TG: Water Rights Section FEB 12 2001
199
 FROM: Groundwater/Hydrology Section IVAN GALL - GRANTS PASS
 SUBJECT: Application G- 15253 Reviewer's Name

WATER RESOURCES DEPARTMENT MEMORANDUM

Date: February 12, 2001
To: Groundwater/Hydrology
From: Ivan Gall – Grants Pass 
Subject: GW Application **G-15253**

Applicant: Lawrence Wendell and Noretta Lynn Baker
Seek: 60 gpm for 13.5 acres; 33.75 acre-feet
From: 1 drilled well, Williams Creek sub-basin, Rogue Basin
Proposed Use: Supplemental Irrigation (Hay during April-October)
Quad Name: Williams

State Observation Well # 261
Steve Miller Shop Well, 38S-5W-14

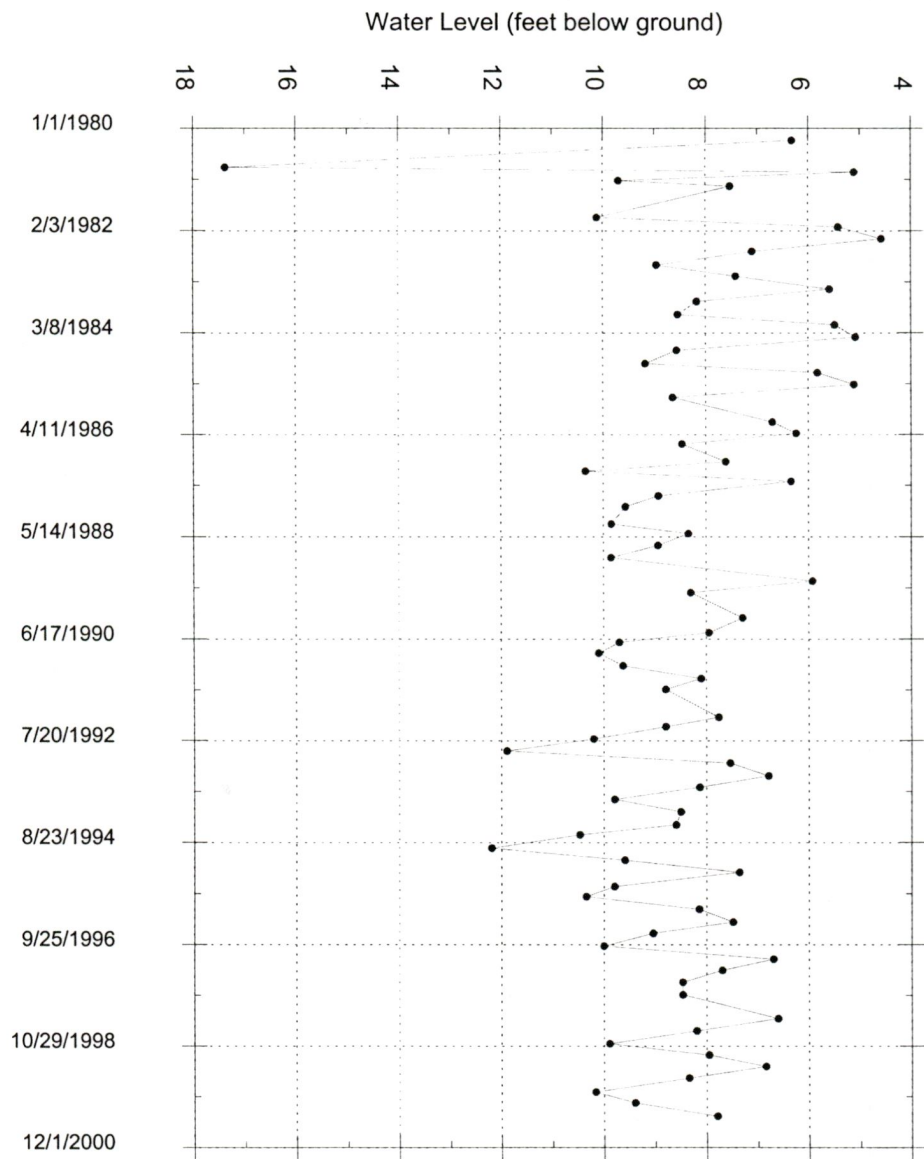
Some long-term water level data from a state observation well (#261, Steve Miller Shop Well) exist for this area (hydrograph is attached). This well is located approximately 6 miles from the subject wells. Water level data collected at well #261, from approximately 1981 to present, indicate a seasonal fluctuation of approximately four to six feet, with no long-term water level declines. Unfortunately, this data is of limited value due to the distance between the subject wells and well #261, and the uncertainty of a well log for well #261.

Baker Aquifer Test - Pumping Well (JOSE 17473/51032)
September 22, 2000

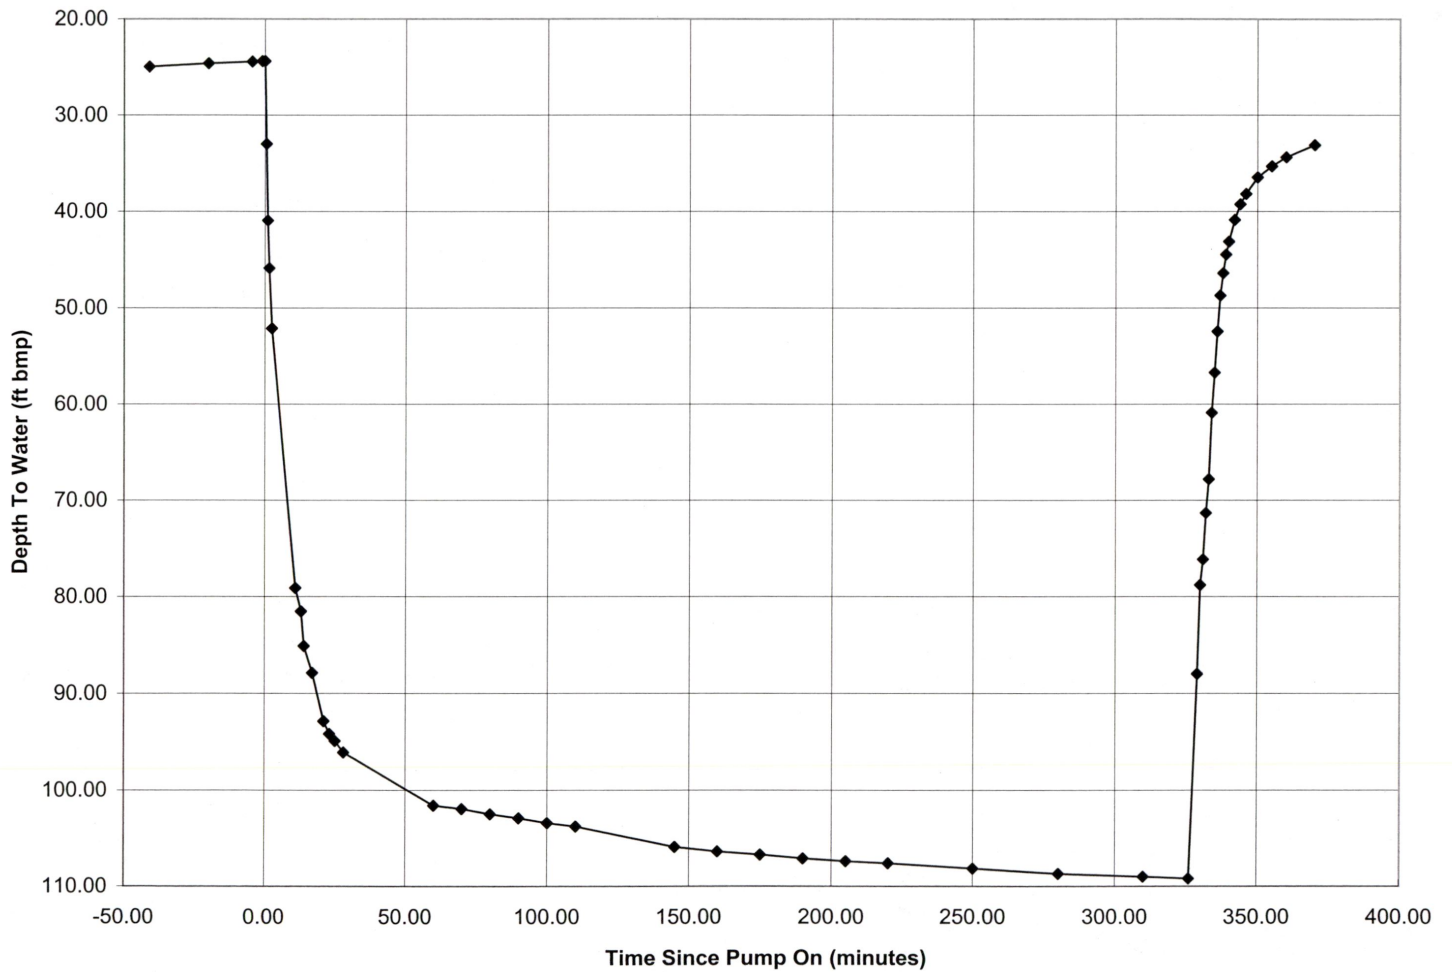
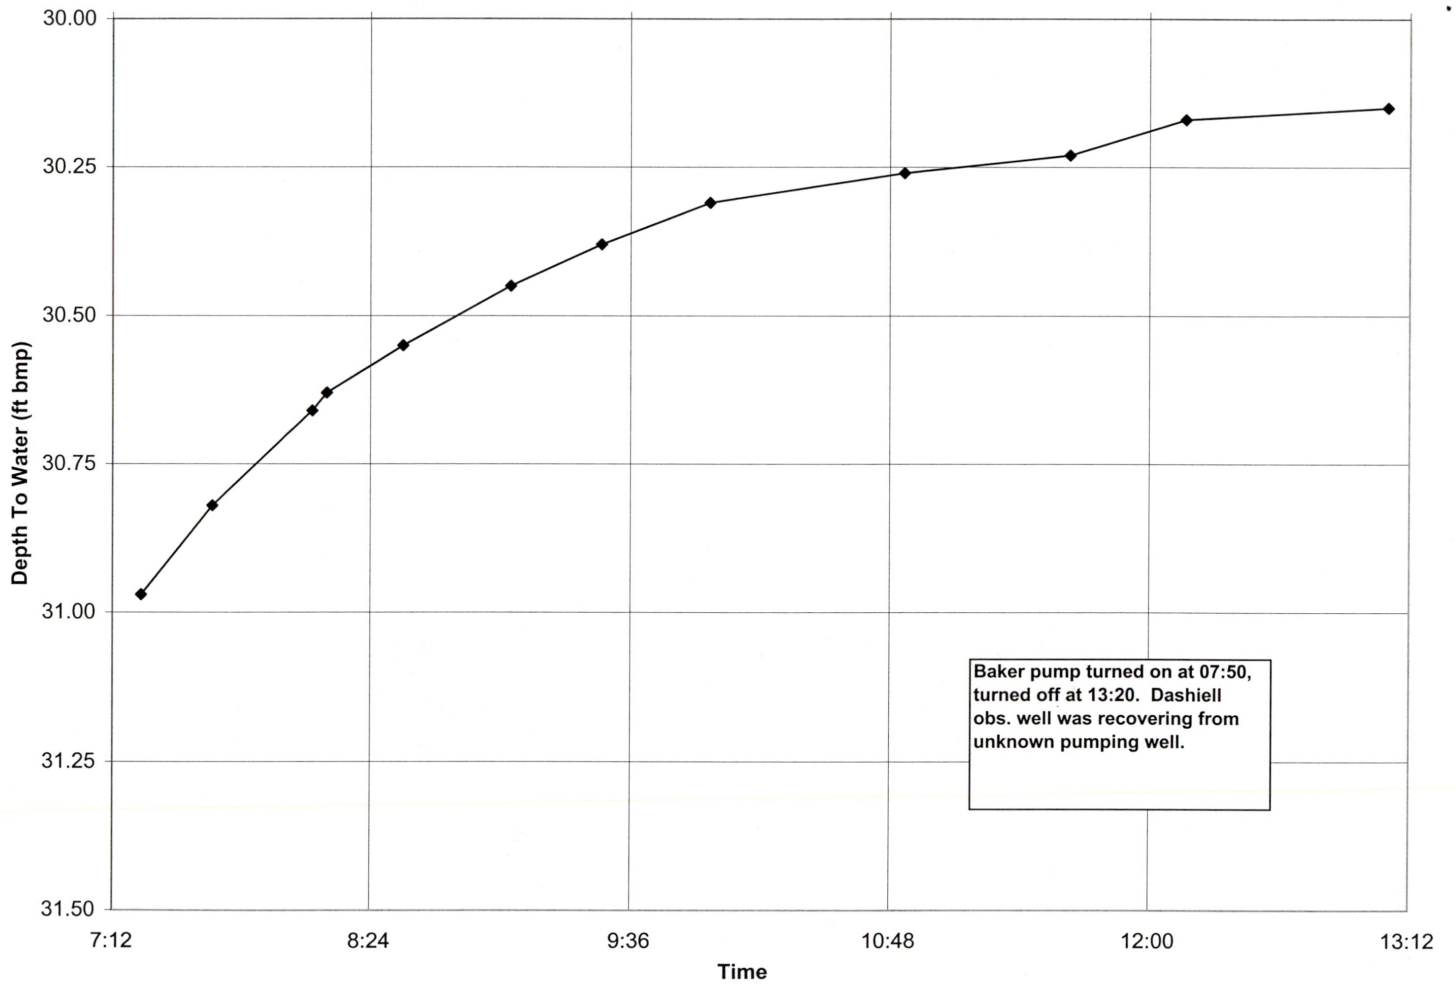
Early time data for the Baker pumping well is sparse due to measurement difficulties. The water level probe hung several times, and several openings in the sanitary seal had to be tried. The southwest bolt hole provided the best measurement access for the probe.

The aquifer test was initially planned for 12 hours of pumping. However, due to lack of response in either observation well, the relatively slow decline of the water level in the pumping well, and staff availability, I decided to terminate the test after approximately 5.4 hours of pumping. At this point in the test, no apparent boundary conditions were evident, and no influence on nearby wells was observed.
